Re: Application of Bush River Utilities, Inc. for an approval of New Schedule of Rates and Charges for Sewage Service provided Residential and Commercial customers in all areas served.
PSC Docket No.: 2004-259-S

**THE OFFICE OF REGULATORY STAFF
DIRECT TESTIMONY AND EXHIBITS
OF
WILLIE J. MORGAN**

**DOCKET NO. 2004-259-S
BUSH RIVER UTILITIES, INC.
APPLICATION FOR RATE INCREASE
TEST YEAR ENDED DECEMBER 31, 2003**

BUSH RIVER UTILITY REPLACEMENT WASTEWATER TREATMENT PLANT

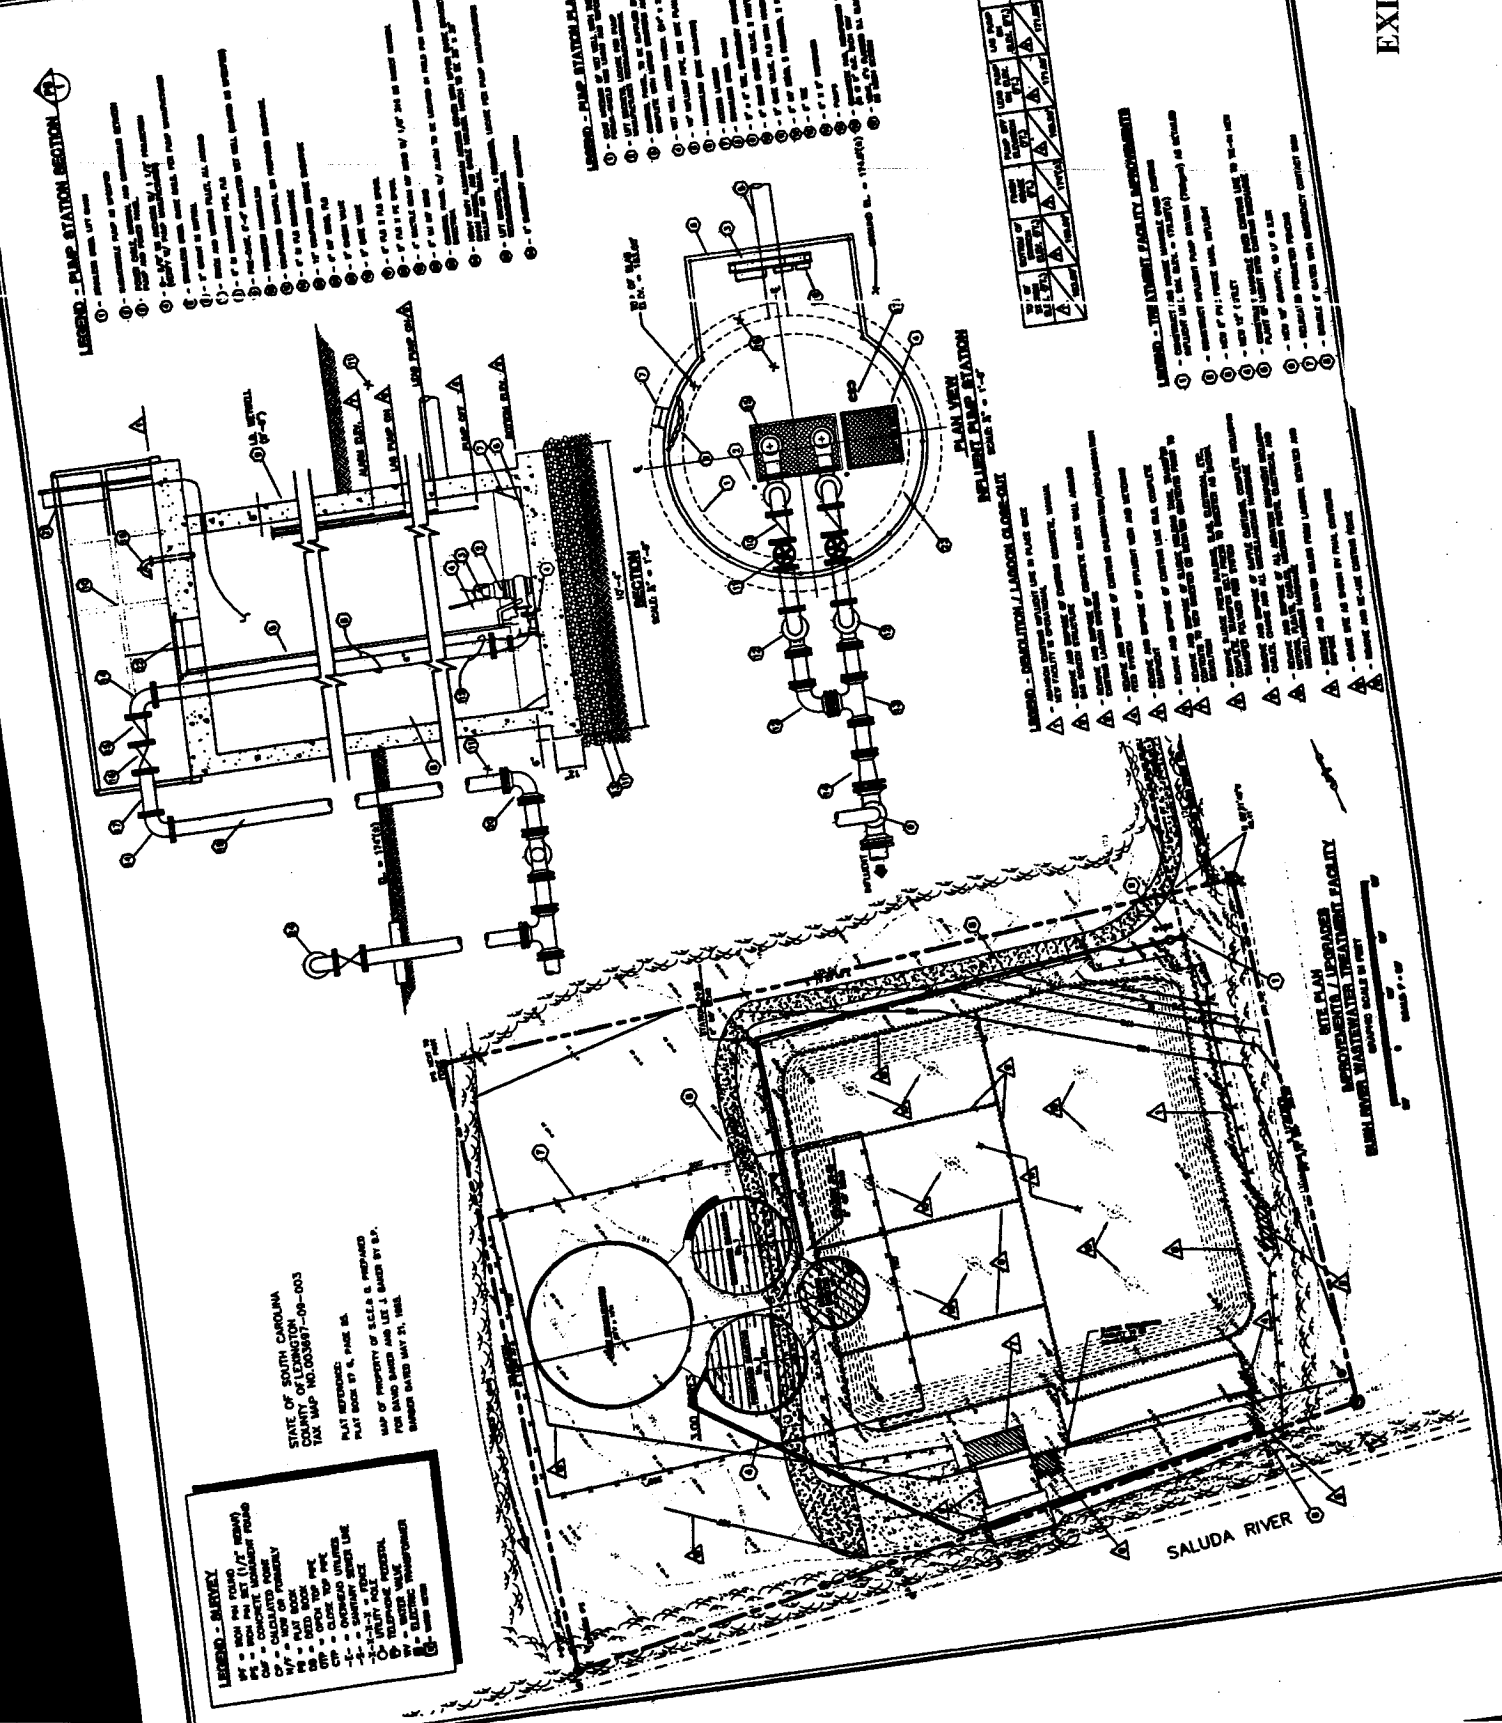
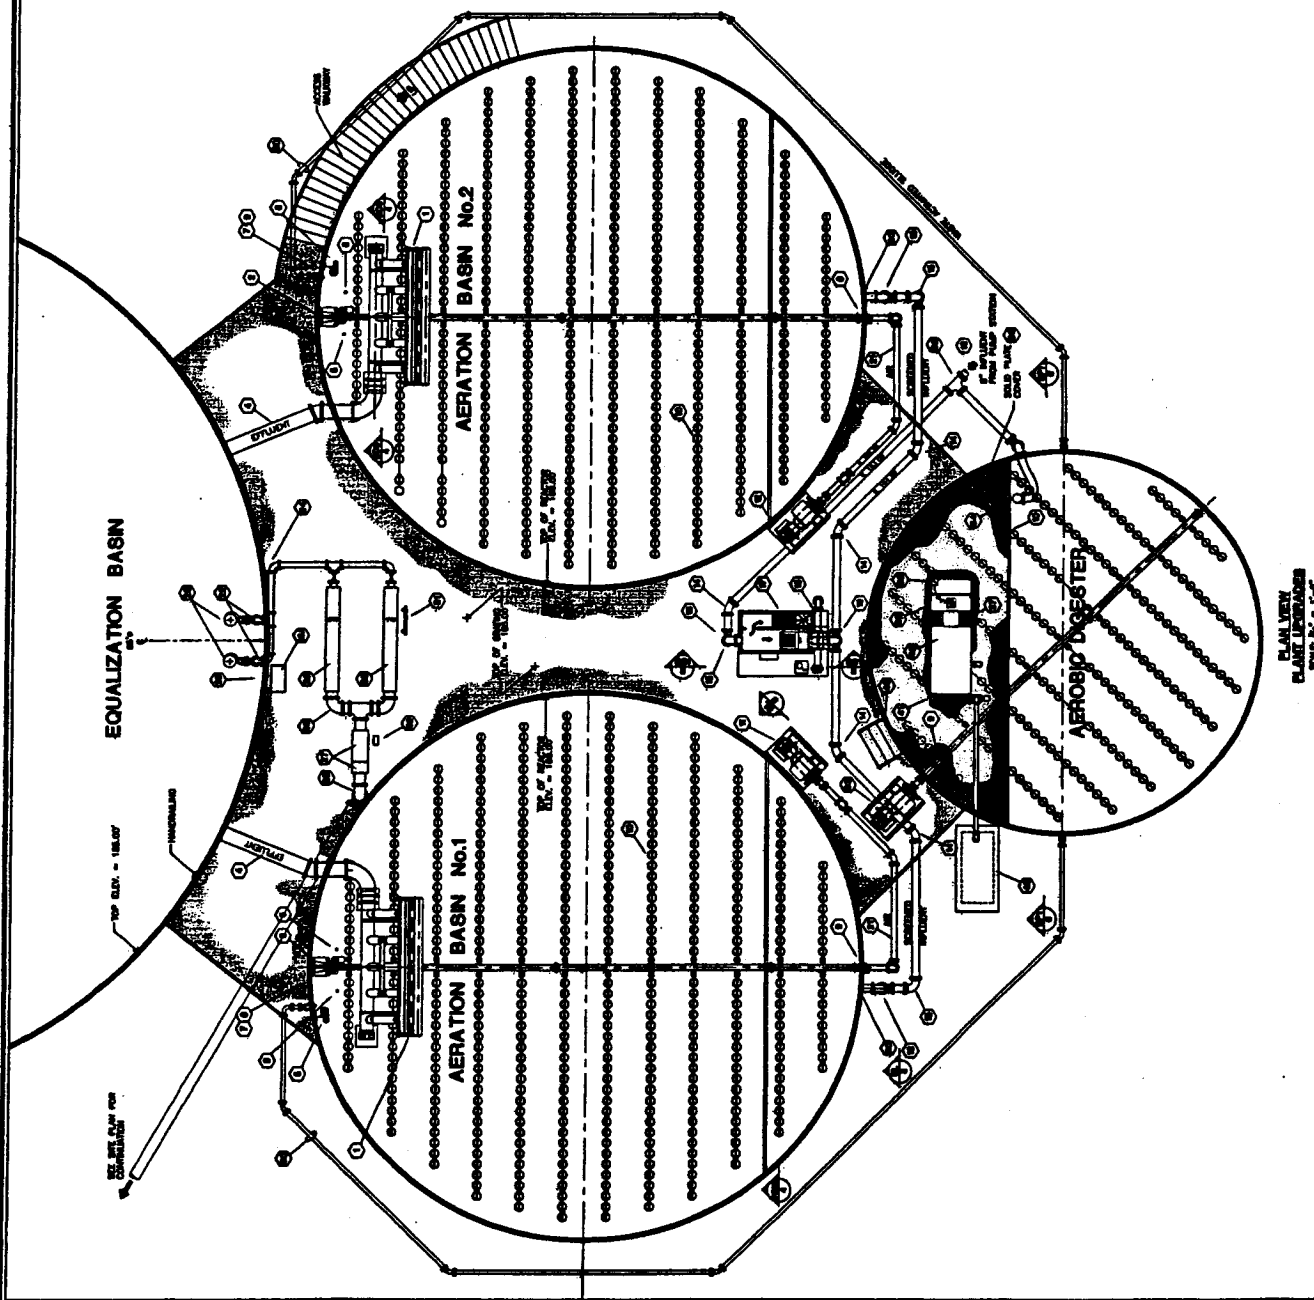
12 A. BRUI's existing treatment system is currently having difficulty meeting the limits
13 in its National Pollutant Discharge Elimination System ("NPDES") permit.
14 Exhibit WJM-4, consisting of pages one through seven, is a copy of the initial
15 design for BRUI replacement WWTF. These plans have been revised by BRUI
16 because of some concerns by DHEC; however, ORS has not yet received an
17 updated copy of the revised plans.

16 Following what BRUI described as failed negotiation efforts, BRUI proposed to
17 upgrade its existing wastewater treatment facility with a replacement facility.
18 BRUI obtained the appropriate approval from DHEC in a construction permit
19 issued on November 29, 2004. As part of the DHEC approval process,
20 conformance with the Water Quality Management Plan for the Central Midlands
21 region was assessed. The proposed wastewater treatment system which includes a
22 screening unit, aerobic digester, dual aeration basins, equalization basin, and a
23 disinfection unit could assist BRUI in meeting the NPDES permit limits.

1 The disinfection unit to be installed is an Ultraviolet (“UV”) disinfection type
2 system. While this type of disinfection system could be effective, it is imperative
3 that BRUI properly maintain the treatment process and control the level of its
4 total suspended solids (“TSS”) in its wastewater that pass through the unit. As
5 noted on Exhibit WJM-3, BRUI is not properly controlling its sludge build-up in
6 the treatment lagoon for its current treatment facility. Improved wastewater
7 treatment management practices must be implemented in order for BRUI to
8 comply with its NPDES permit. Because of concerns related to the current
9 management practices, I am apprehensive about whether BRUI should be allowed
10 to expend revenue generated from customers on a system that requires efforts to
11 remove such high levels of solids considering this issue has been observed as a
12 continuing problem (See, Exhibit WJM-6). An alternative disinfection method

13 would be the use of a chlorination system similar to the existing disinfection unit.
14 This is a proven method that is utilized by most WWTFs in South Carolina and
15 may be less costly to construct and operate for BRUI. A chlorination and
16 dechlorination system is more flexible and can be adjusted or modified more easily
17 to meet the needs of the overall WWTF. BRUI has provided no cost comparisons
18 of different options; therefore, no cost analysis of any options has been conducted.
19 The Sequential Batch Reactors (“SBRs”), while slightly oversized, could translate
20 into a small savings to the customers of BRUI and DSI. Additional maintenance
21 obligations will be required for the upgraded facility due to the use of a pump
22 station versus an all gravity flow system that is currently being used.
